CVL Network – Network Code Condition G1 Network Change Proposal: Variation 2 to the Establishment of the Pontypridd Blockade - Weeks 27 & 28, 2024

Appendix A – Proposed Network Changes in Pontypridd Blockade Weeks 27 & 28 2024

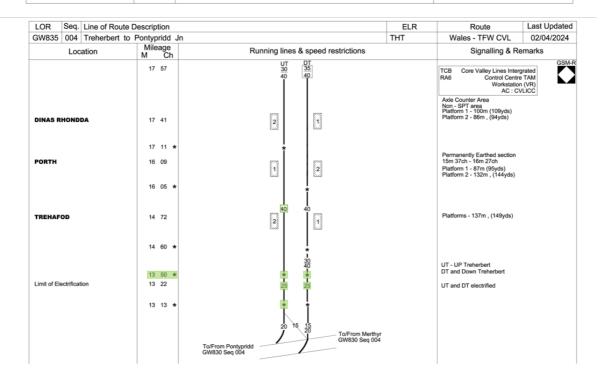
To support the alterations described above, the following revisions will be made to the GW830 and GW835 of the Western Route Sectional Appendix (June 2024)

The new requirements are shown in Red whilst requirements that are to be removed are shown in Green . Any explanatory notes are in Blue.
